Subject: BAR Actions - 611 Preston Place = April 2015

Certificate of Appropriateness Application

BAR 15-04-04
611 Preston Place
Tax Parcel 050112000
Scott and Christine Colley, Owner
Replace Windows

CITY OF CHARLOTTESVILLE BOARD OF ARCHITECTURAL REVIEW STAFF REPORT April 21, 2015

611 Preston Place Upstairs

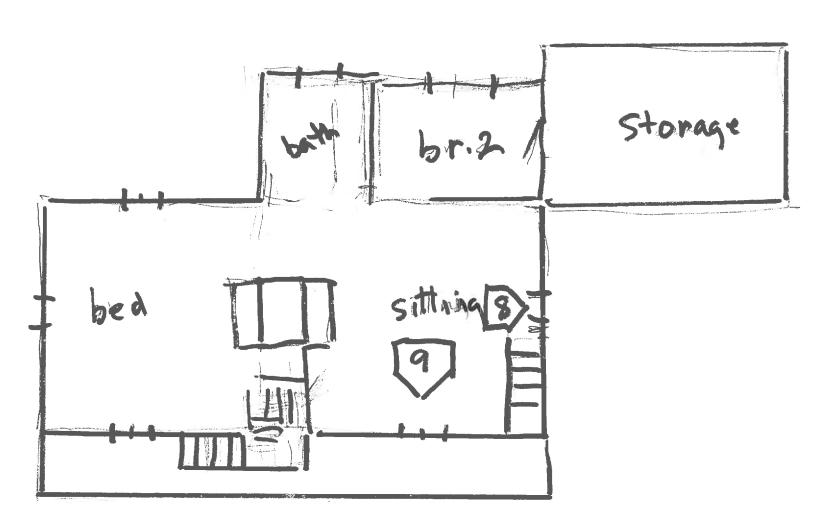
- 1. Living Room, (See photos 1 & 2). Two mid-twentieth century double hung windows.
- 2. Back of house, bedroom & hall (See photos 3 & 4). The corner to right of center in the photo is the bedroom, and the window to the right is in the passage leading to the bathroom.

- 3. Dining & Kitchen pairs of large double hung windows. (See photo 5). These have added panes of glass, so have some insulation, and may be left as is and painted pending budget. They are installed with scanty support between the paired windows, and it may be advisable to add support and/or to replace the paired windows with single windows in the same mullion pattern.

- 4. Kitchen windows. (See photos 6 &7). There are two of these smaller windows in the kitchen in addition to the paired double-hung window on the street side wall.

- 5. Upstairs, windows at centers of N and S walls of the original part of the house. (See photo 8).
- 6. Upstairs, 4 paired 6-light small casement windows in the gables. (see Photo 9).

The BAR approved the application as submitted (7-0-1 with Mohr abstaining).

The proposed aluminum clad wood windows are appropriate.
